**NOTICE OF A REGULAR MEETING
BONDURANT PLANNING AND ZONING COMMISSION
JANUARY 12, 2023**

TITLE: - RESOLUTION NO. PZ-230112-03 considering recommended approval of the Hawthorne Crossing 2 Site Plan/Preliminary Plat

THE CROSSING

BUILDING #2 ELEVATIONS

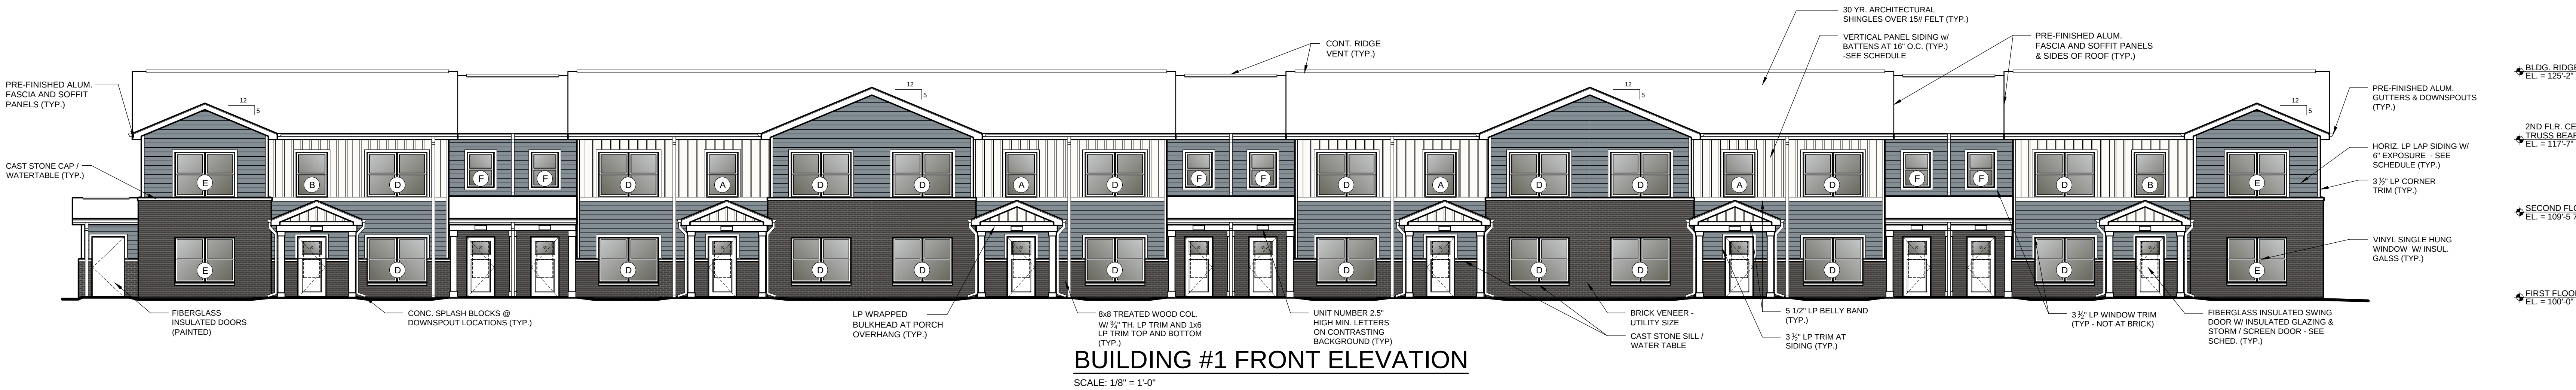
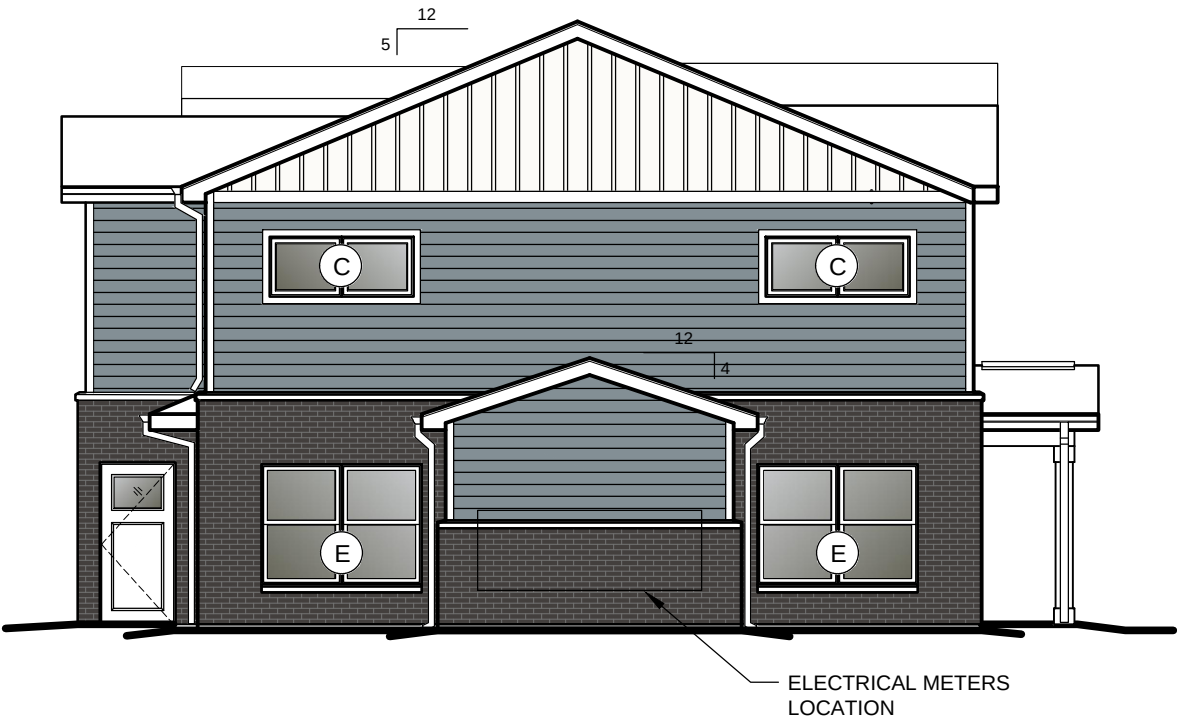
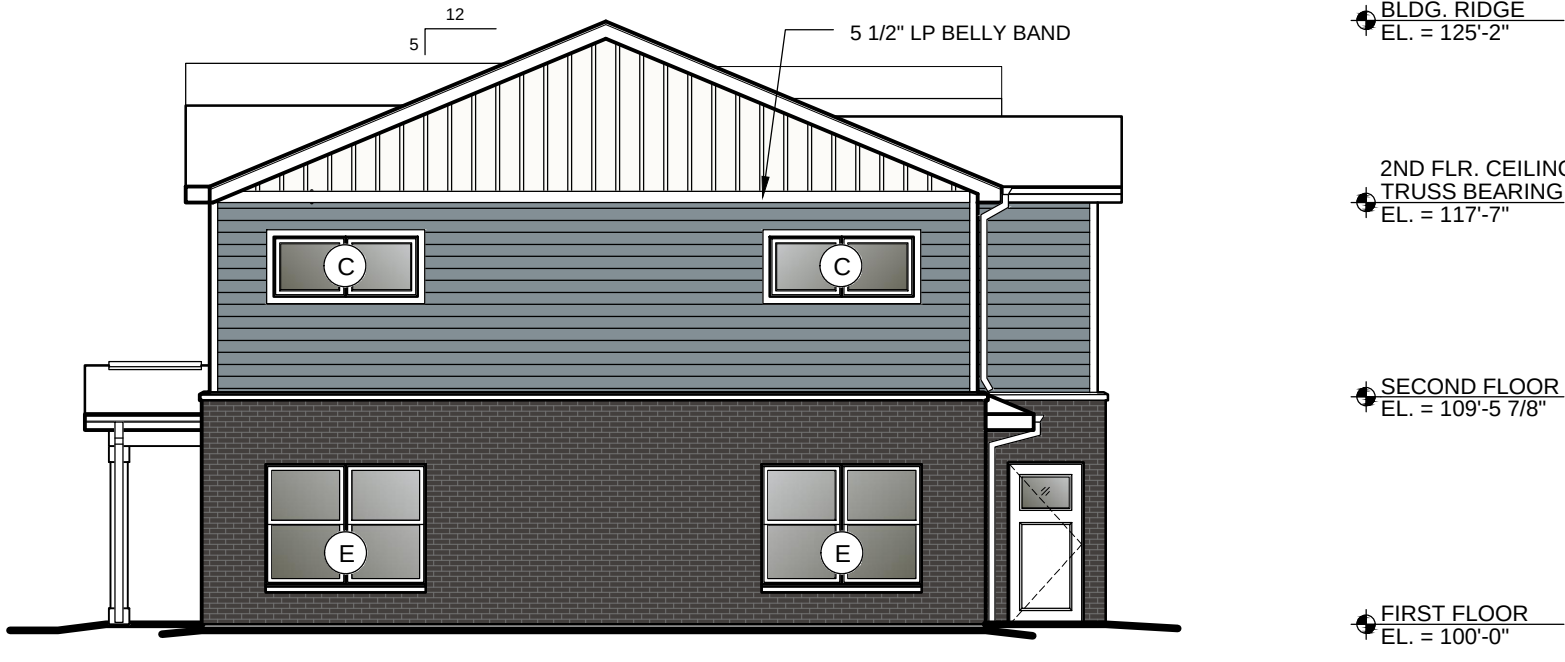
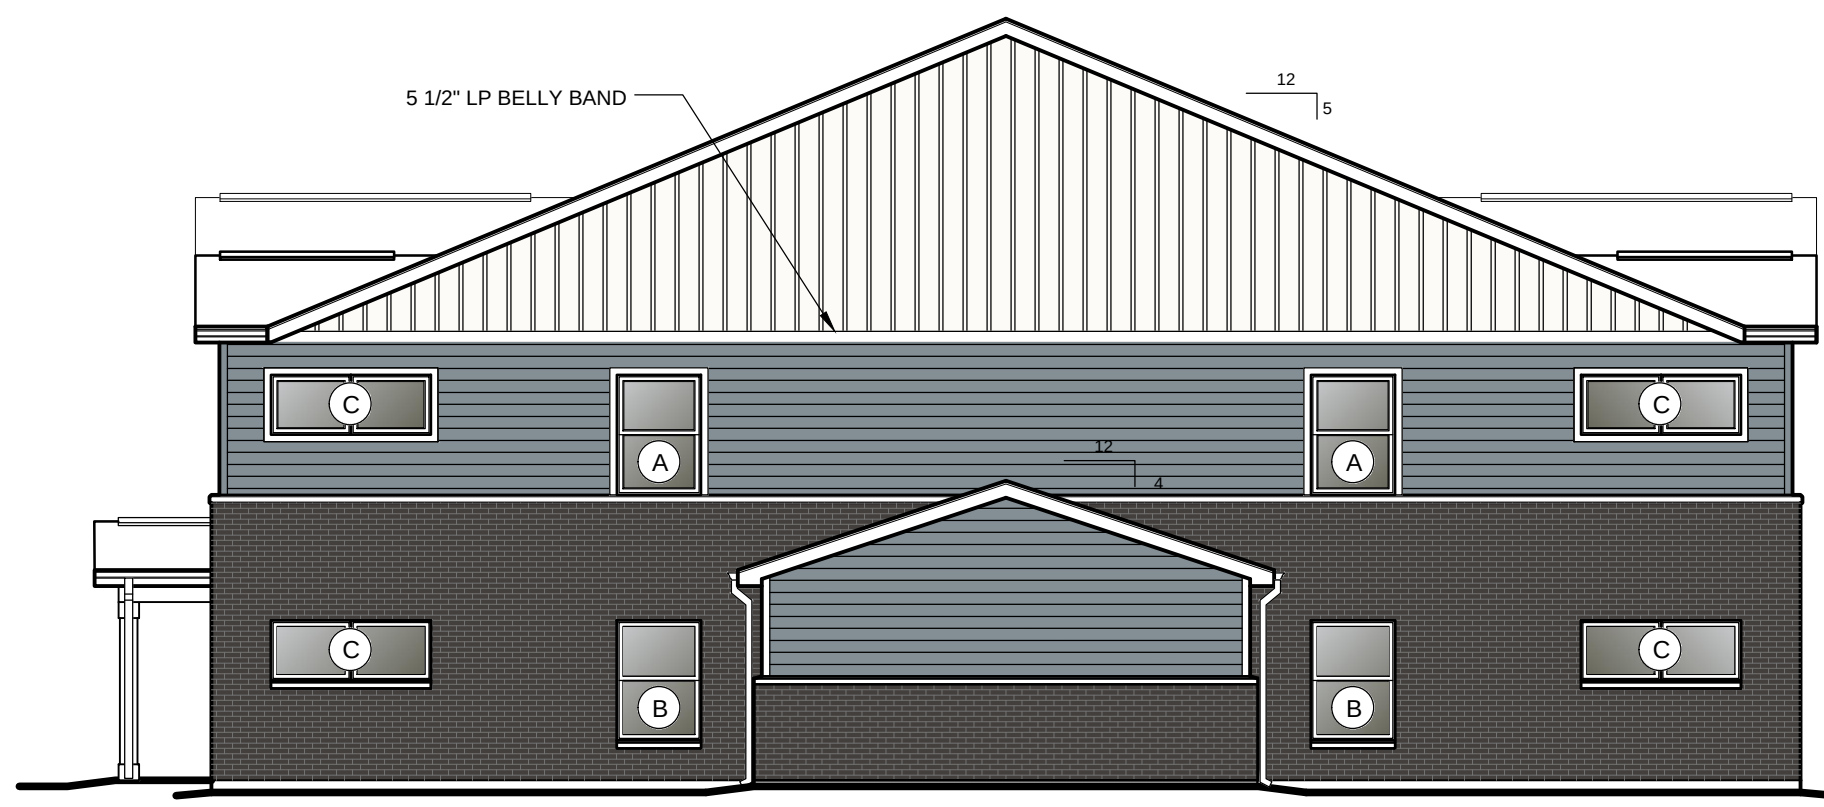
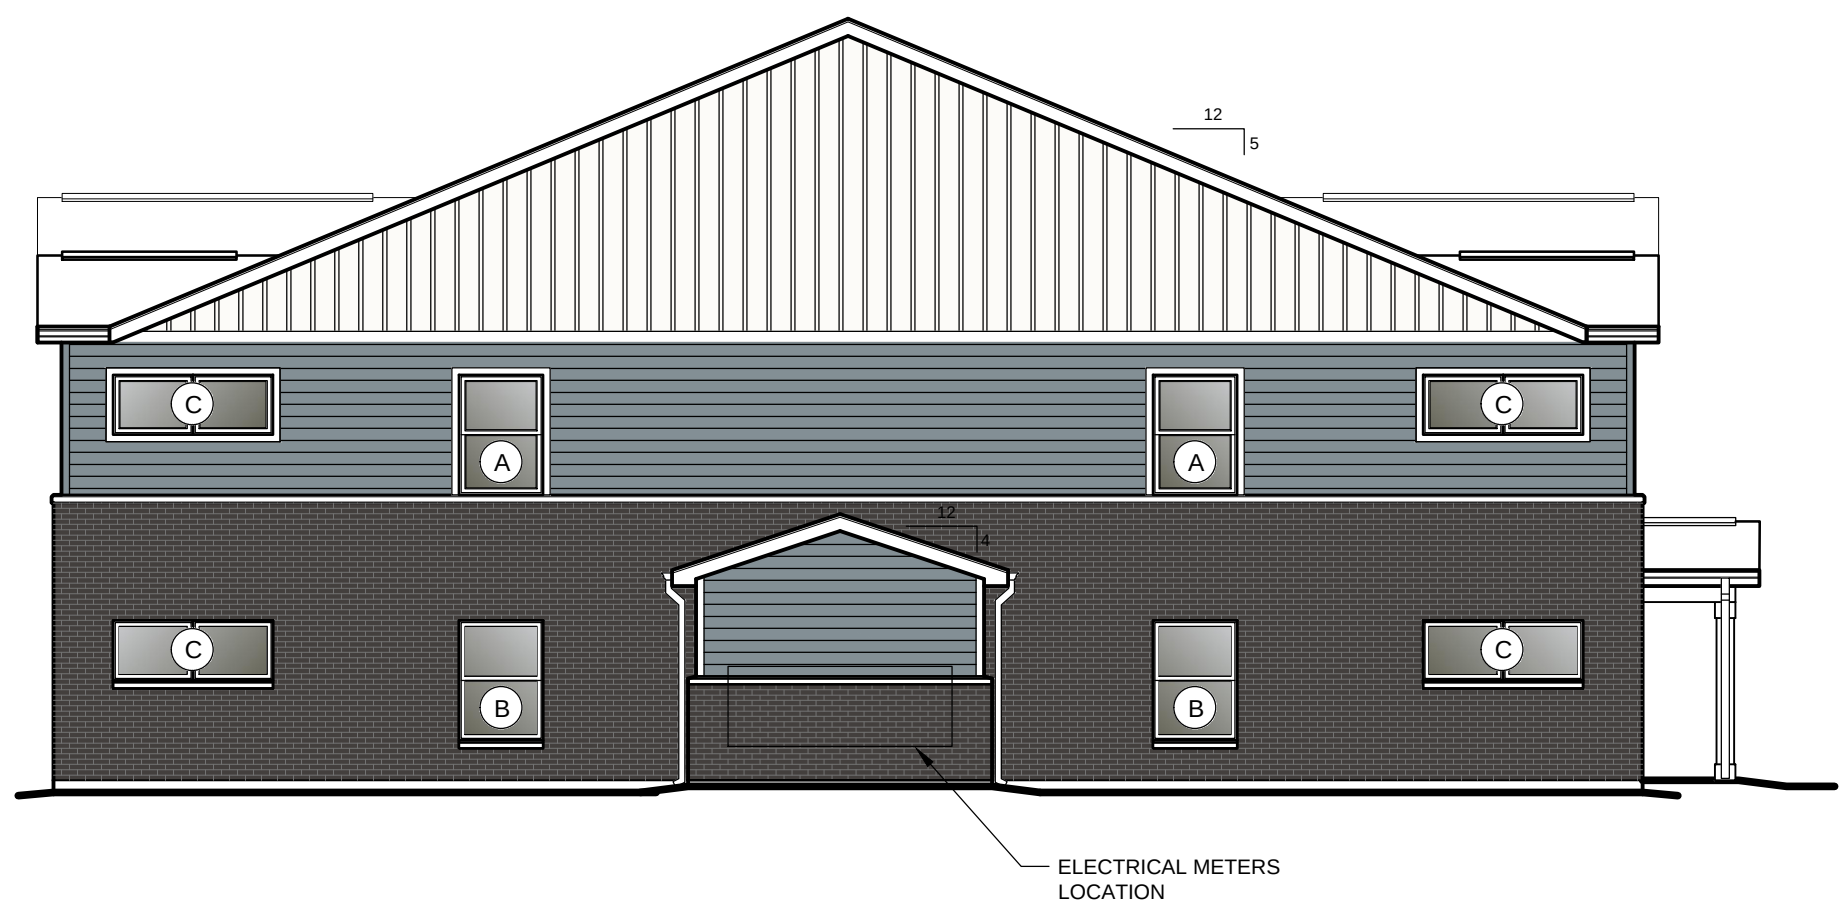
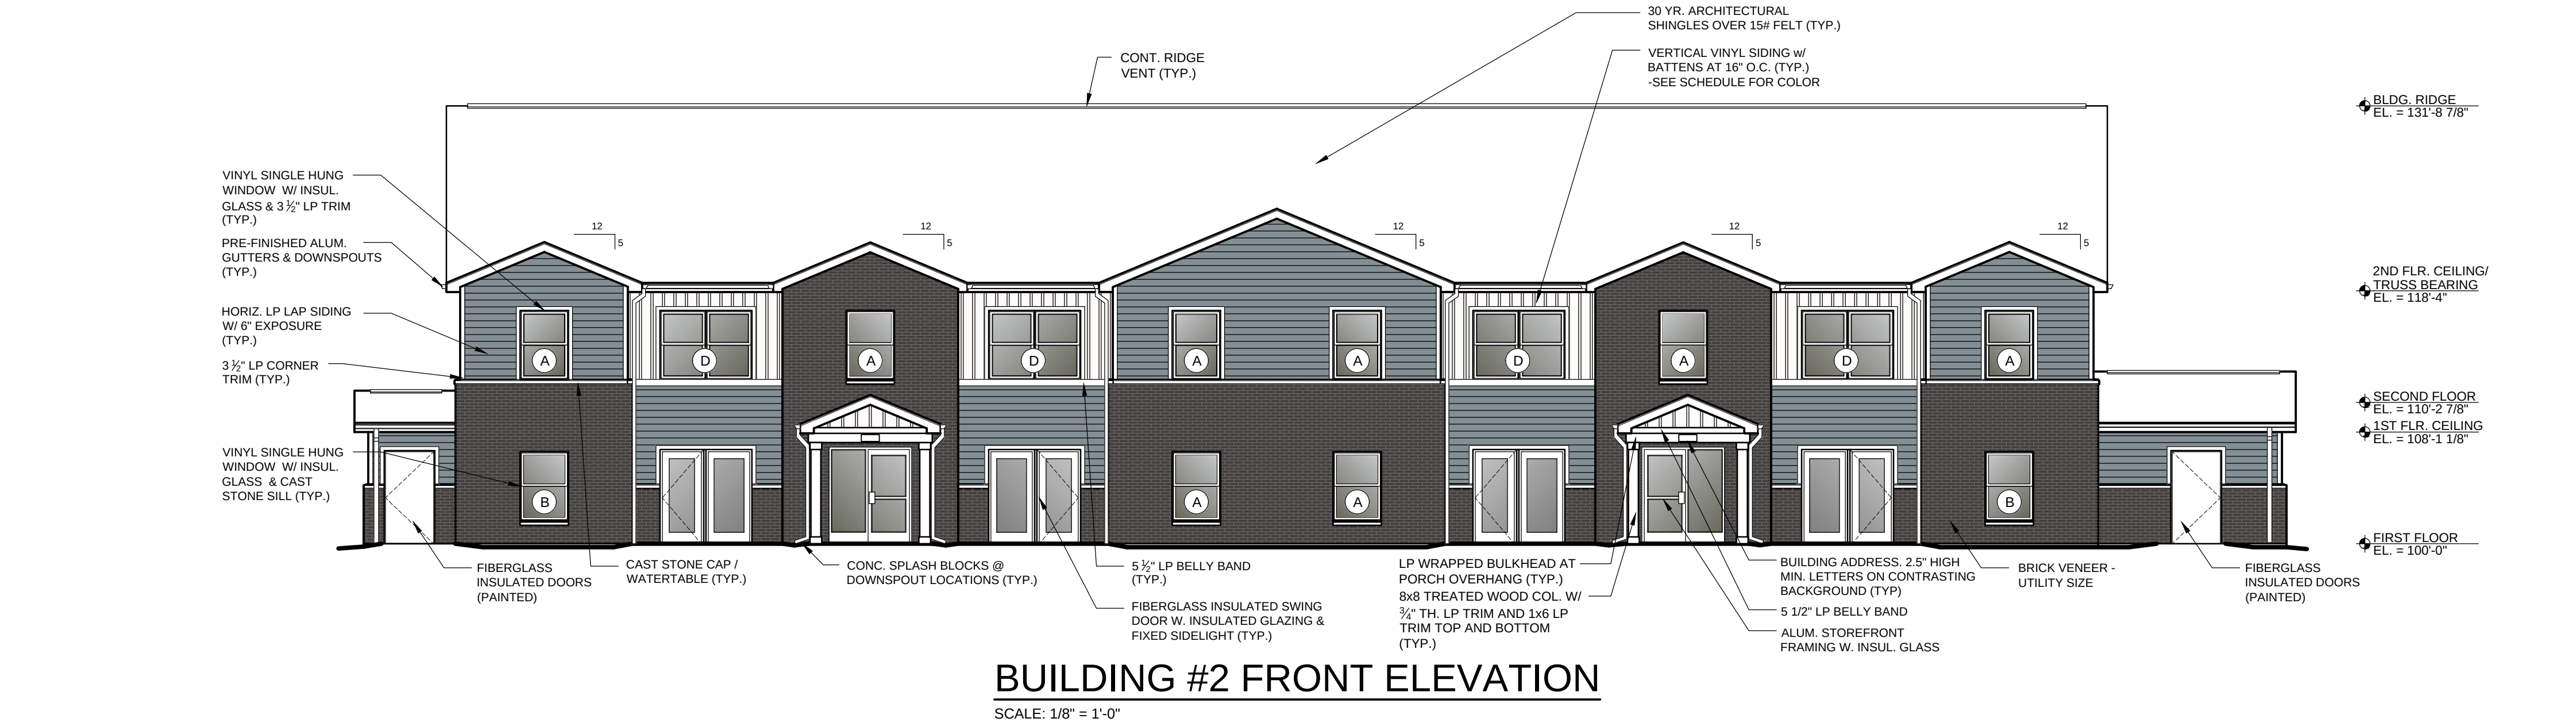
- Building Materials:
 - Hard Surface Requirements
 - At least 20% of multi-family structures shall be brick, stone, or a similar substantial material. This requirement applies to both those facades that face the public right-of-way and those facades that do not face the public right-of-way which are not screened. If a non-street facing façade is screened, the primary materials must be present as at least trim. Door and window openings can count toward this 20% requirement if surrounded by brick, stone, or another substantial material. *Page 1 of the elevations sheet shows brick veneer being utilized. Appears to be meeting just fine, but elevations to be updated to provide a brick/stone calculation requirement for each building façade elevation of each building.*

- At least every fifty linear feet (50'), wall and roof planes shall contain offsets or setbacks with a differential in horizontal plane of at least two feet (2'). *Site plan applicant to confirm this is being met for all elevations.*
